#### **BEFORE THE PUBLIC UTILITY BOARD**

) Manitoba Hydro ) Cost of Service Methodology Review )

> REBUTTAL EVIDENCE OF PAUL CHERNICK ON BEHALF OF GREEN ACTION CENTRE

AUGUST 5, 2016

11 Figure 1: Subtransmission as Alternative to >100 kV Transmission

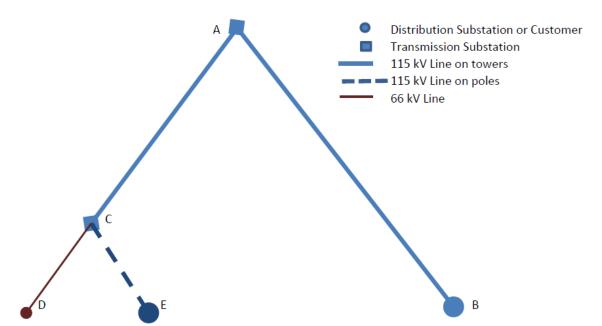
3 Yes. Figure 1 illustrates a simple portion of a transmission system, with 115 A: kV lines on towers serving distribution substations or industrial customers at 4 points B and E. For the station at point D, the utility is able to use a less 5 expensive 66 kV line for part of the distance. If the level of the load at D 6 7 required that the 115 kV system be extended, costs would rise. The 66 kV 8 line saves money; if one class is served only at point D, and another at point B, the total transmission charge (for all voltage levels) for the former should 9 10 be lower.

Figure 1 also illustrates a second point. There are many distinctions among transmission lines, other than voltage, including height, vintage, overhead/underground, and support design. They all serve the same function. Manitoba Hydro arbitrarily selects voltage to split off a portion of the system to be billed only to selected classes, but it could have chosen any of the others. For example, in Figure 1, point E is served by a different design of
115 kV line. A class served only at point B (or otherwise directly from 115
kV lines on towers) could argue that it does not use the 115 kV on poles, and
should not be charged for that equipment. Yet all three delivery points—B, D
and E—receive the same service, and point B may well be the most
expensive to serve.
